STATE OF MAINE
DEPARTMENT OF TRANSPORTATION
16 STATE HOUSE STATION
AUGUSTA, MAINE 04333-0016

January 9, 2018
Subject: Auxiliary Turning Lanes &
Bernard Lown Peace Bridge
Rehabilitation
State WINs: 018650.00 & 022599.00
Location: **Lewiston & Auburn**
Amendment No. 1

SECTION B-B

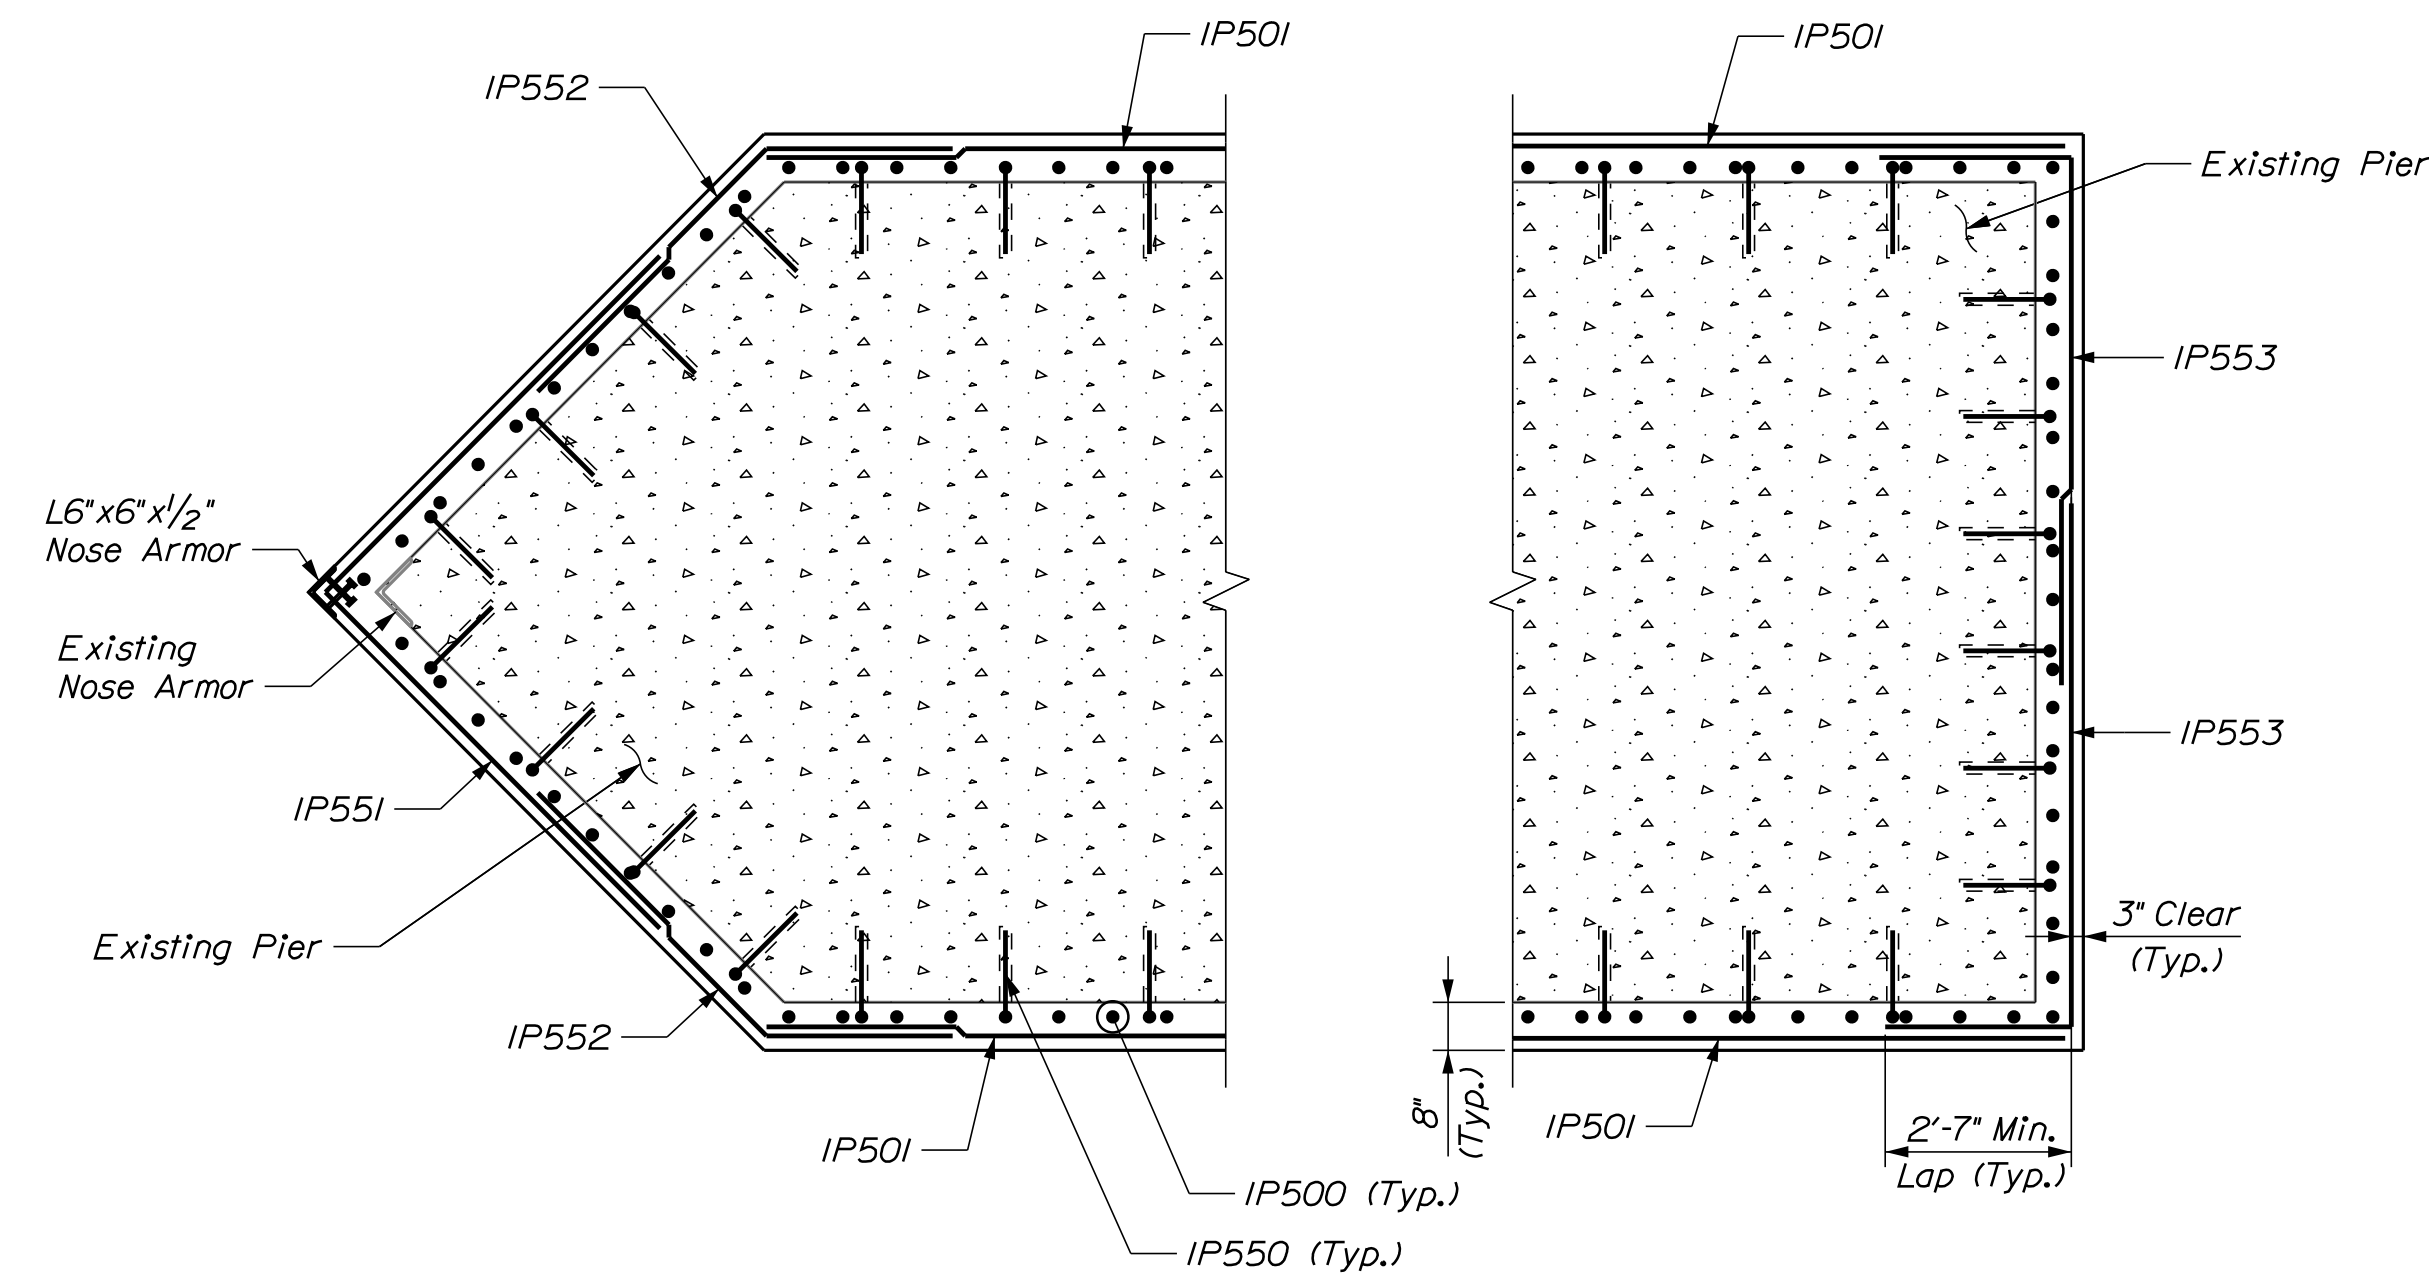
REMOVE SHEET NUMBER 10 OF 20, PIER 1 REPAIR DETAILS, and **REPLACE** with the attached, revised SHEET NUMBER 10 OF 20, PIER 1 REPAIR DETAILS.

Question: How will pier excavation be paid for at Pier No. 1?

Response: Any excavation and disposal of material necessary at Pier No. 1 shall be incidental to the Cofferdam item. A plan note will be added to clarify this.

7. Excavation and disposal of soil shall be considered incidental to Item 511.07, "Cofferdam" and shall be performed in accordance with the requirements of Standard Specification Section 203.

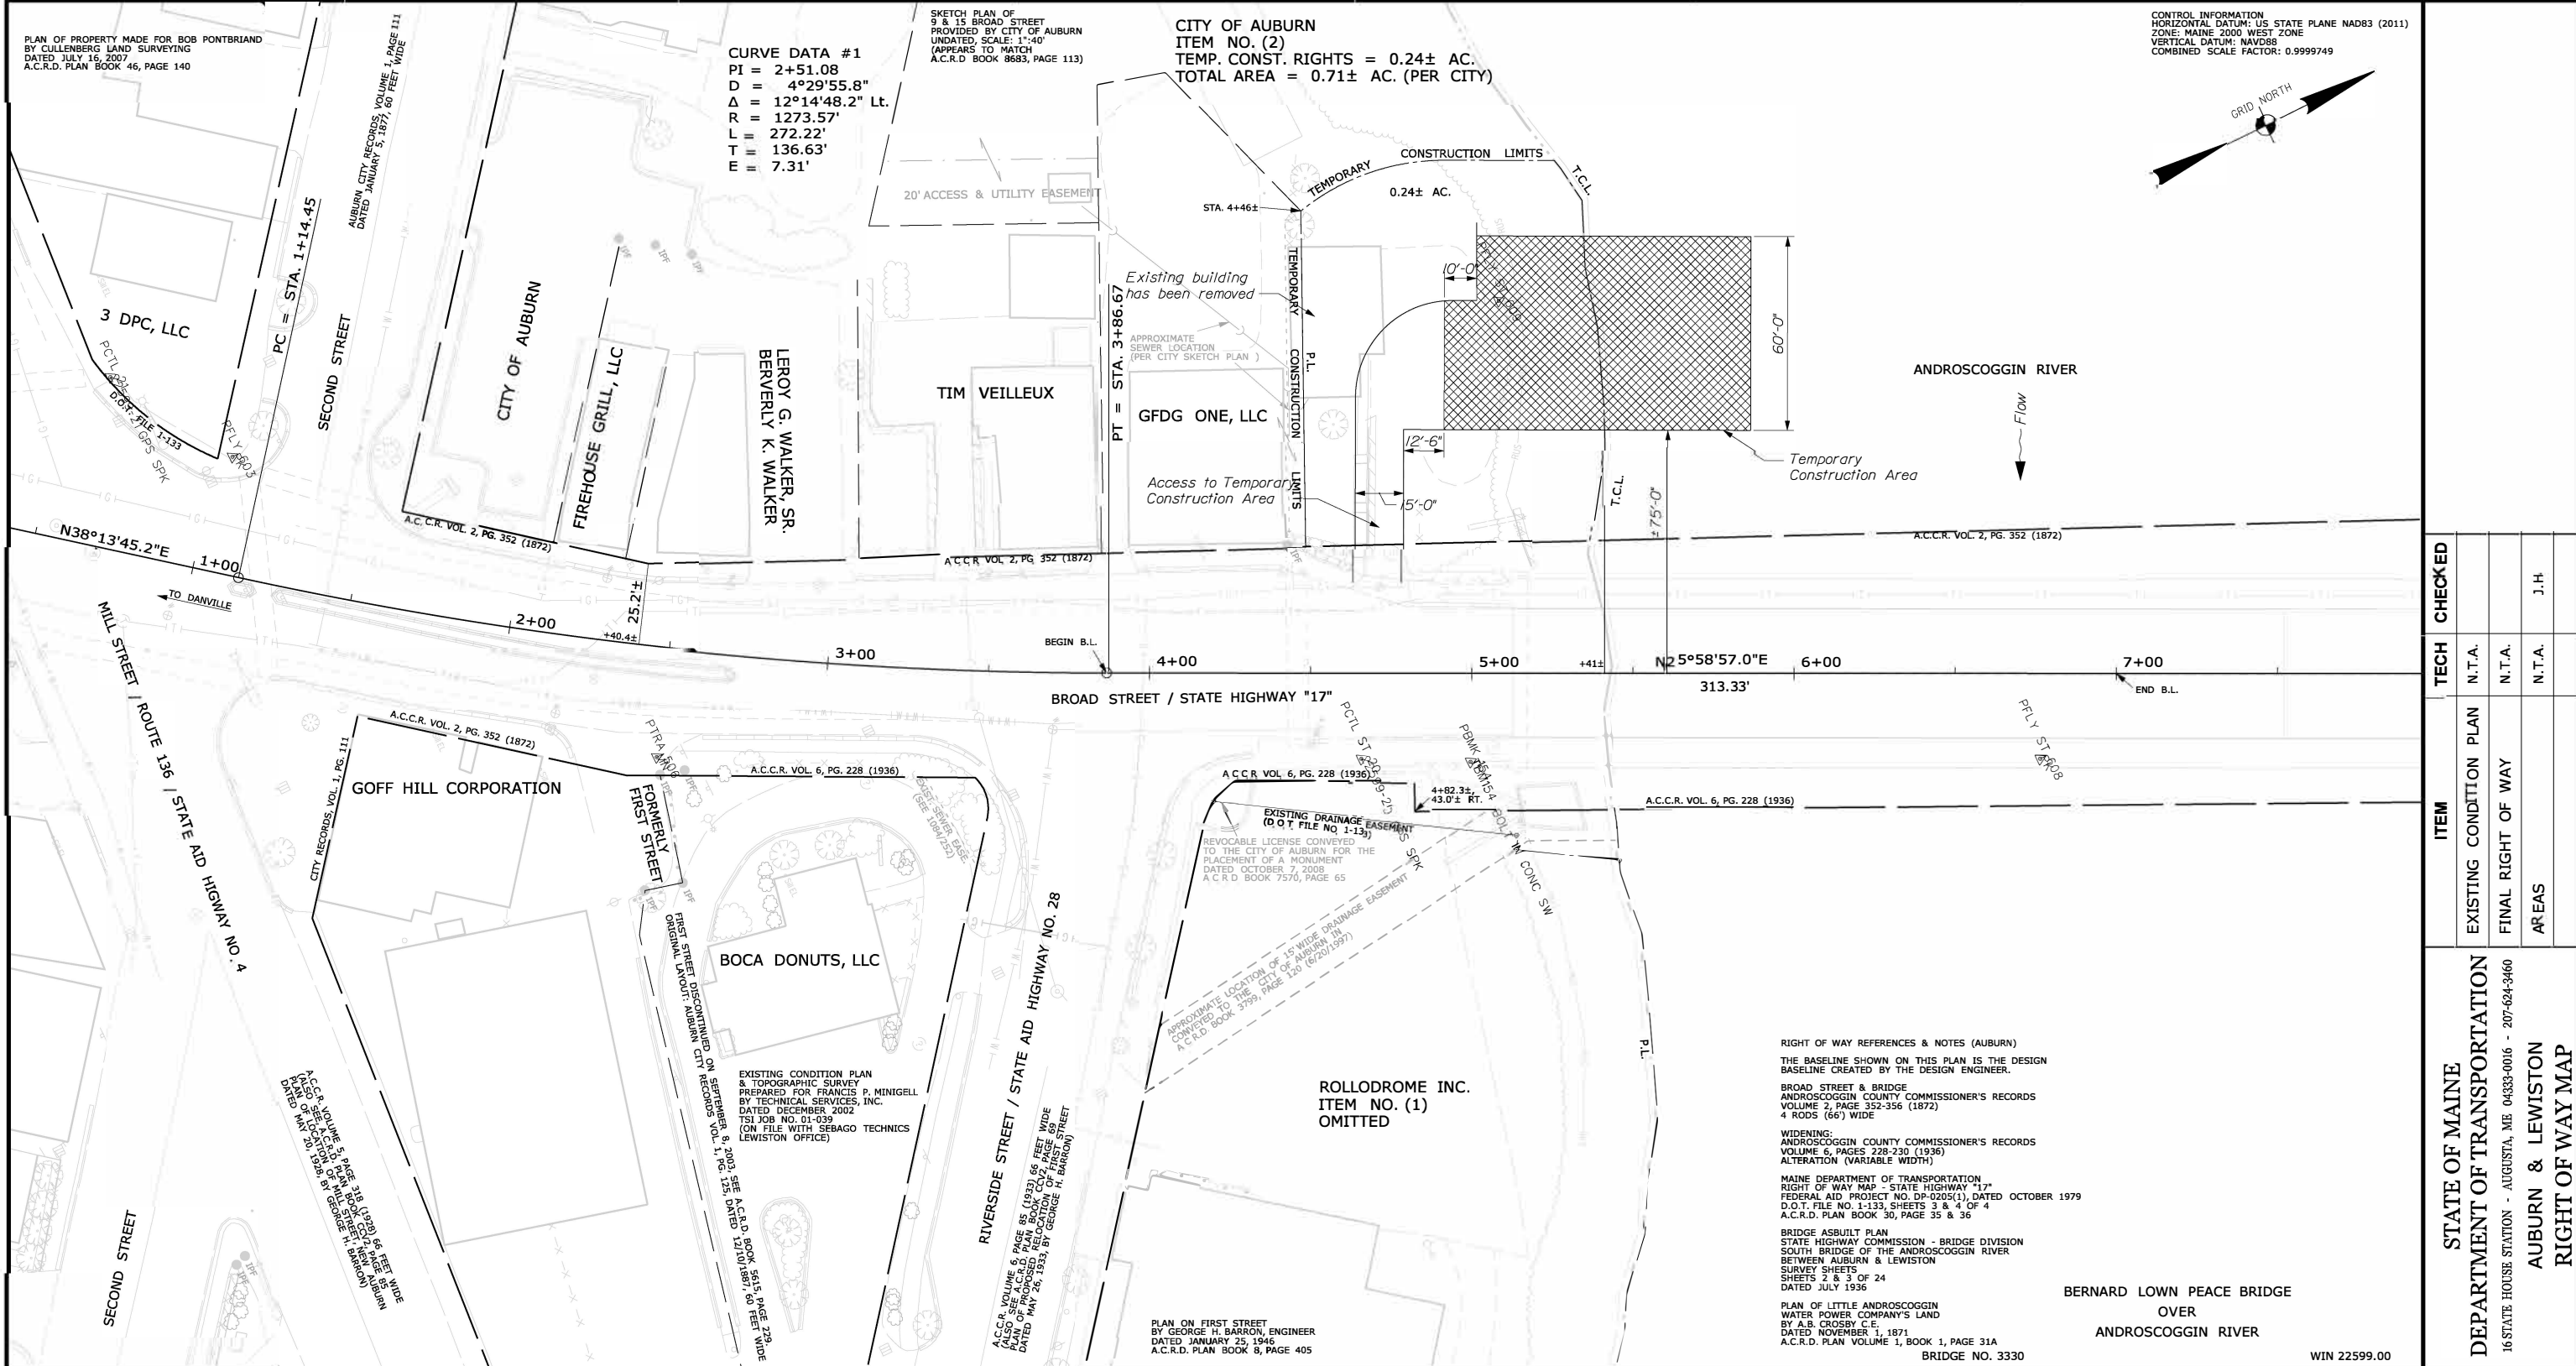
Question: Please provide a Right of Way drawings that details where a contractor can access the river for a temporary ramp / trestle.

Response: See attached ROW map, Federal Aid Project NO. STP-2259(900), SHEET 1 of 3
